SUGAR HILL MIXED-USE DEVELOPMENT

Re: Design Narrative of
Revisions for Historic
District Commission

RE: Sugar Hill Mixed Use Building Inset Panel Detail
119 Garfield Street, MI 48201
BLD# 2019-05307

Areas where warranty would be voided has then inset detail remained

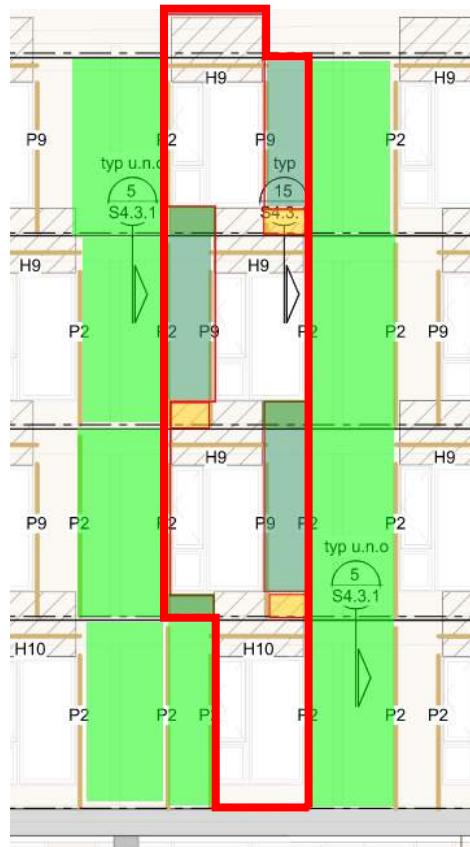
1. The permit drawings specify a fiber cement rainscreen system. When the set went out to bid a number of products were considered. The Hardie plank product selected did not allow for horizontal joints except for at the floor line and at window head and sill conditions. During shop drawing review the condition below was identified as a void in the warranty.

Our team concluded that this detail would change to accommodate the preferred siding product details and warranty. We consider this to be a minor deviation from the permit set reviewed and approved by HDC.

Rendering Part of Package That Received COA on 6/14/2019 (With Window Inset)

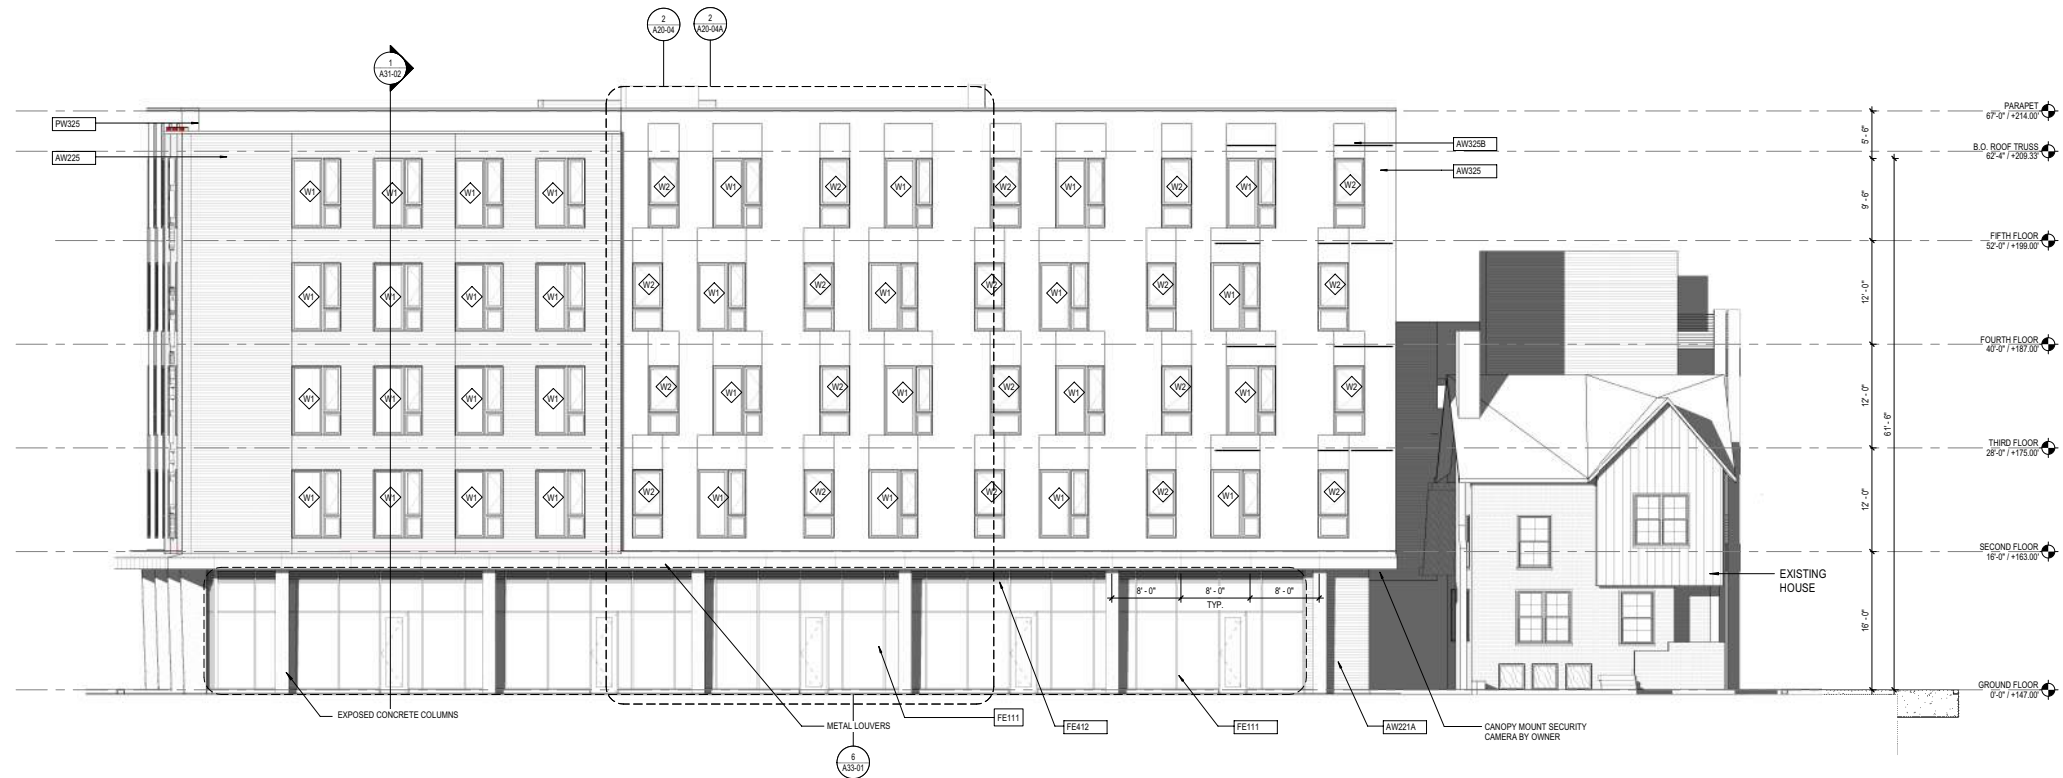
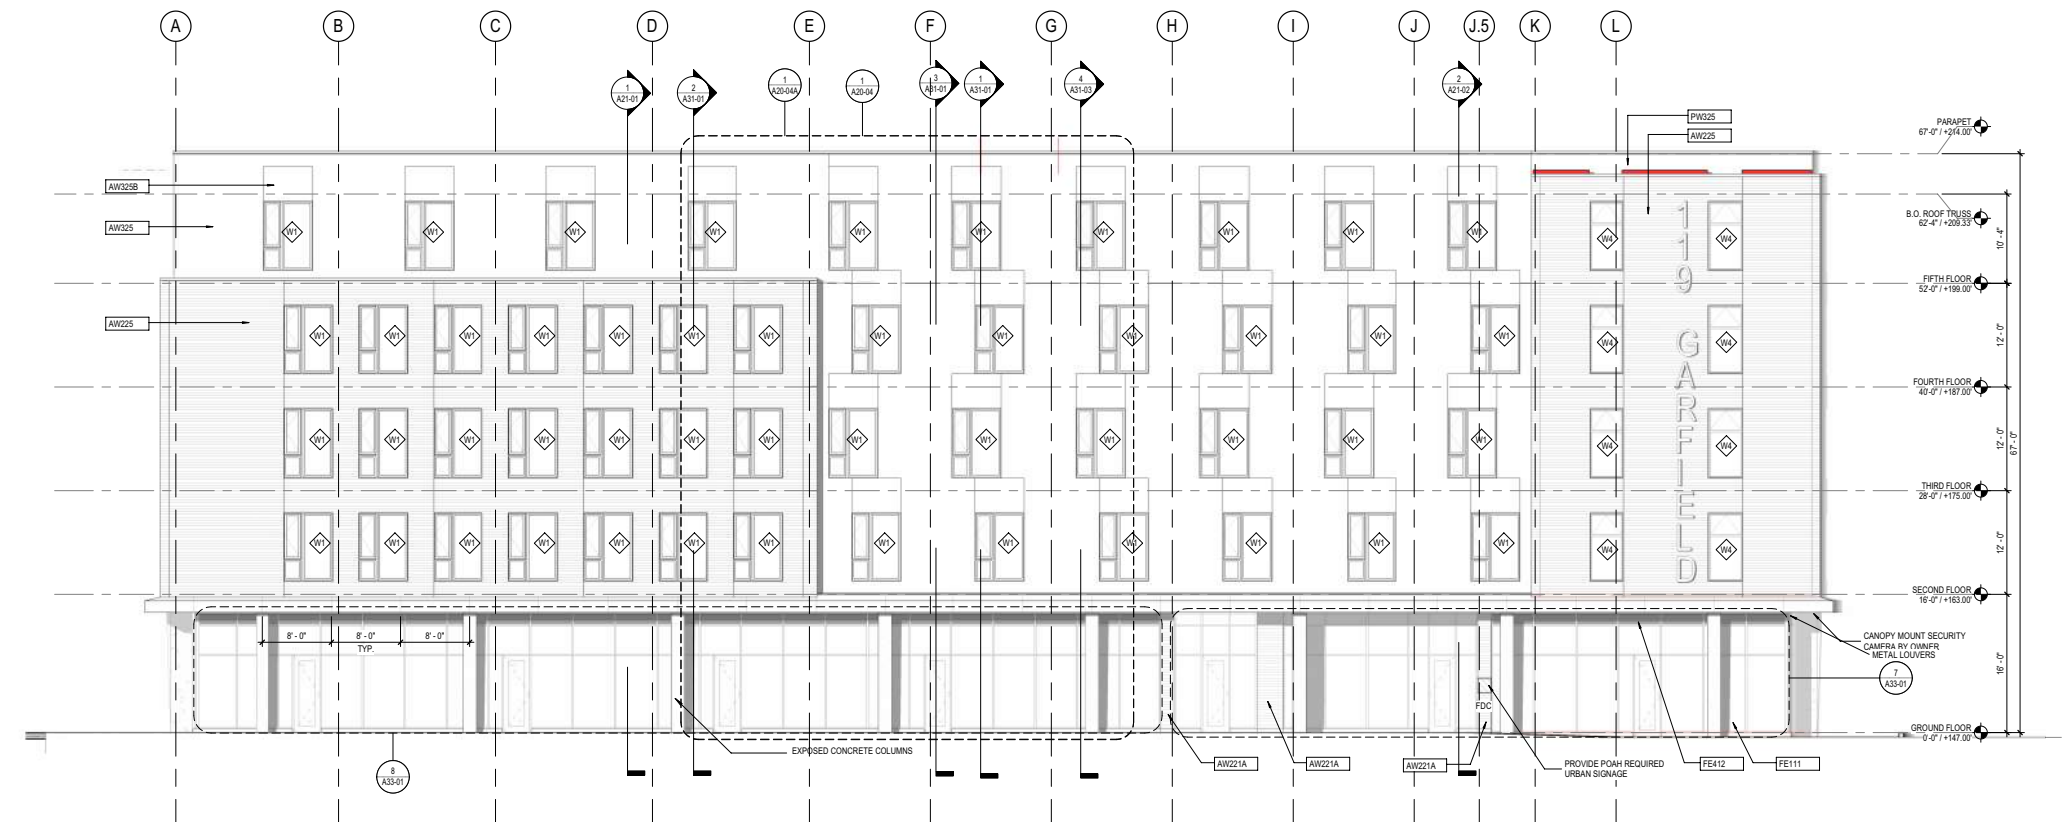
Rendering Showing No Window Inset

Photograph Showing Facade With No Window Inset. (Photo taken on 6/16/2021)

2 EAST ELEVATION- JOHN R. STREET
1/8" = 1'-0"

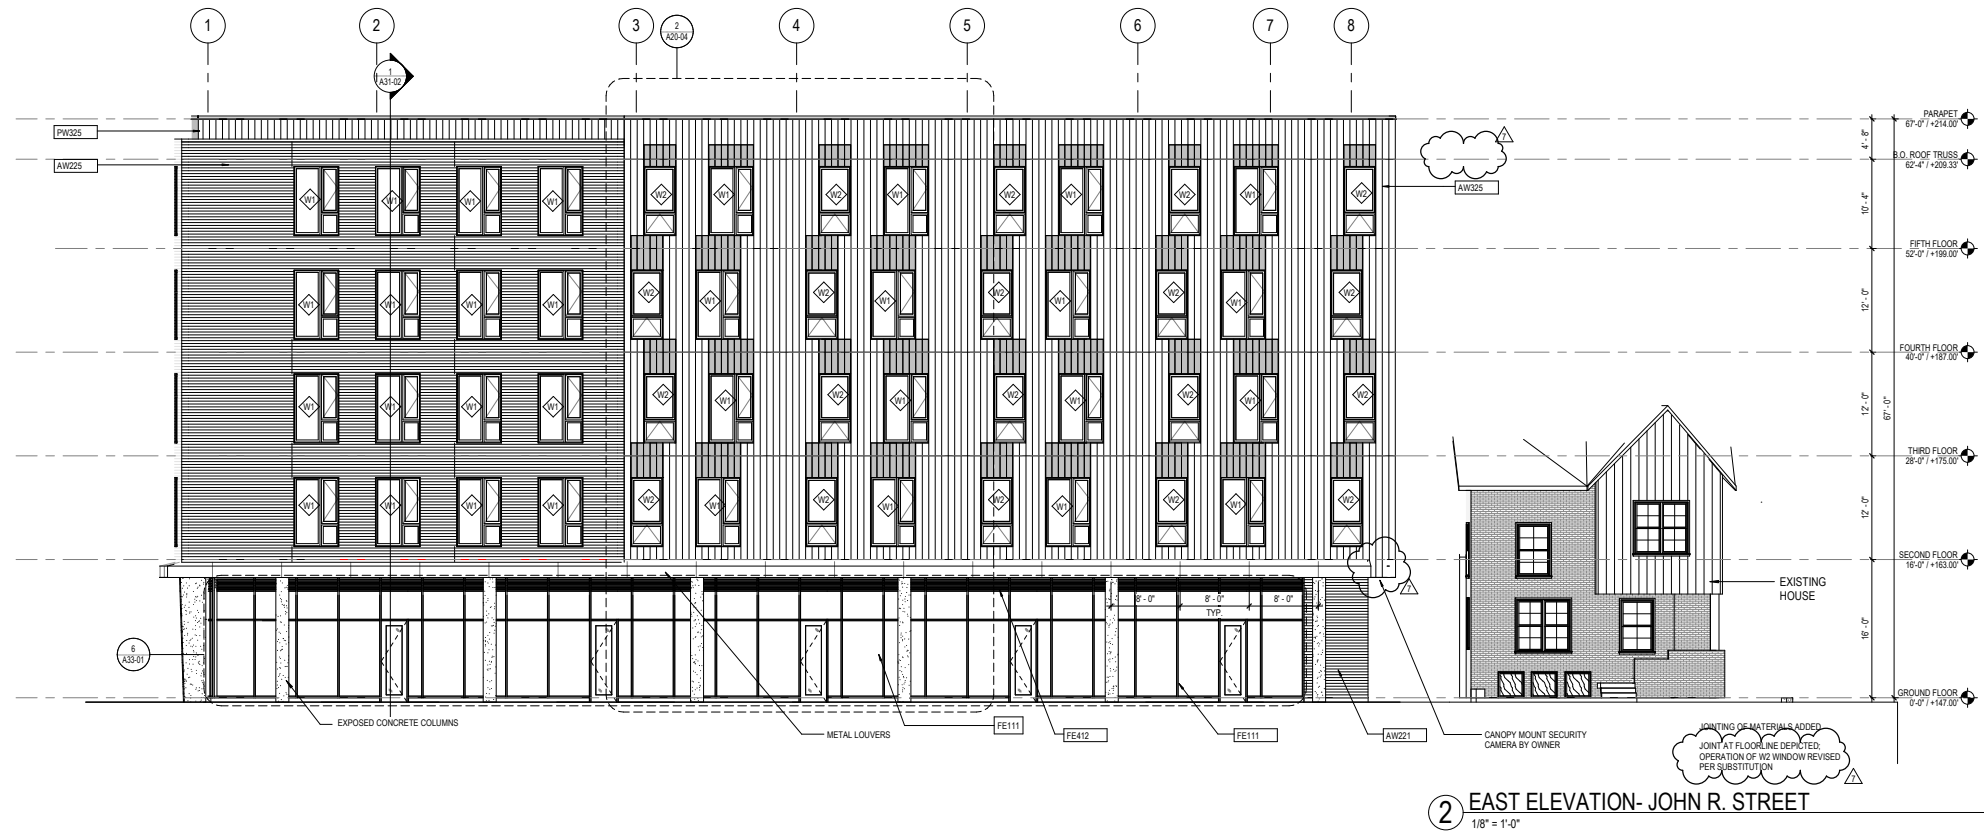
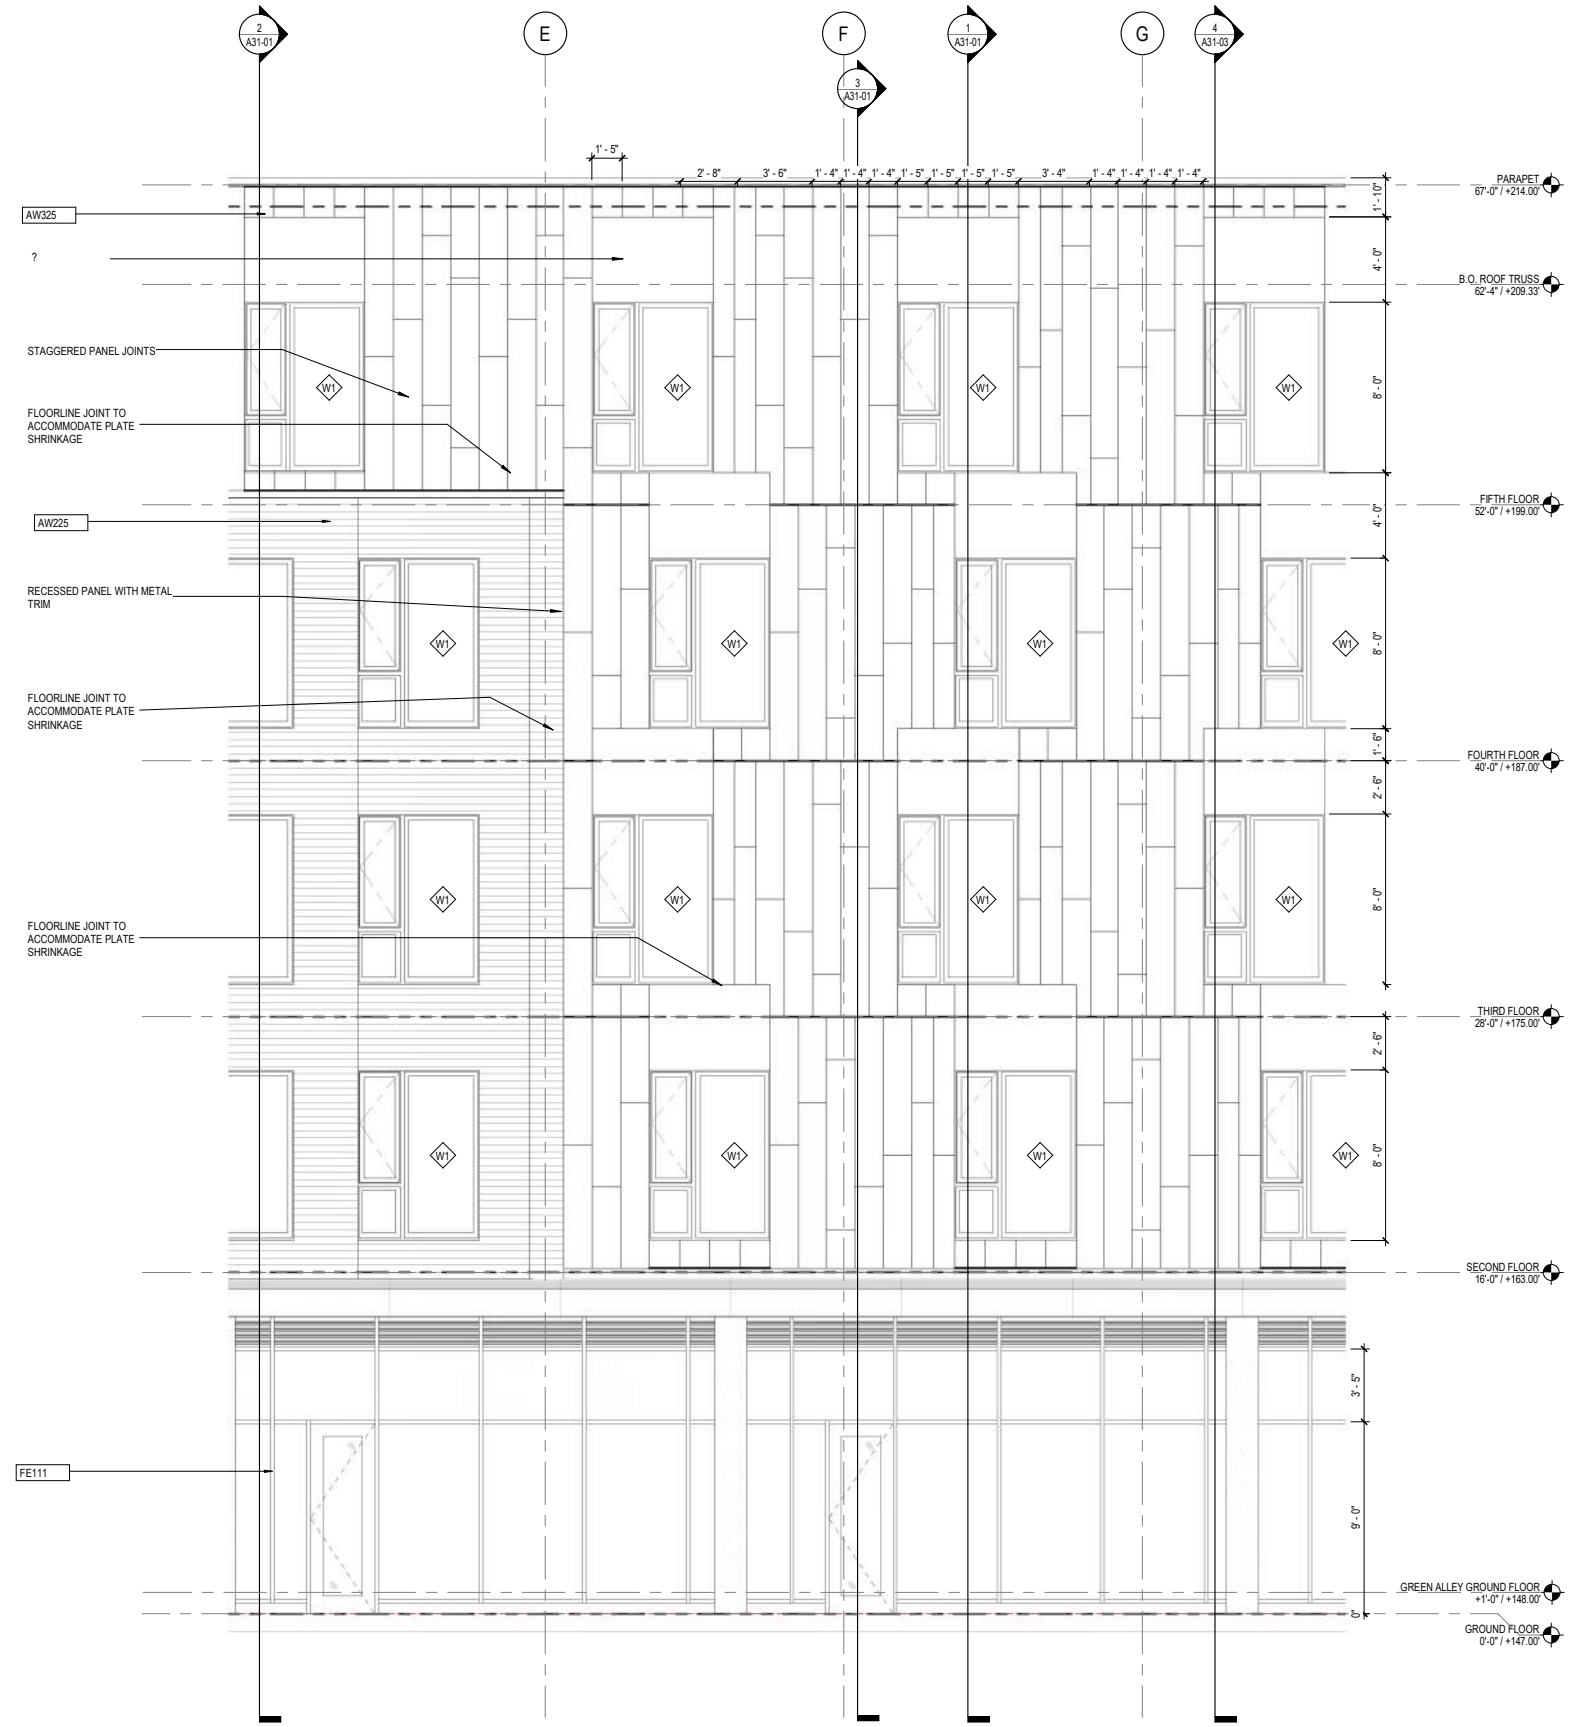
Elevation From Approved Permit Set (Permit received 3/3/2020)

Revised Elevation with Flush Panels
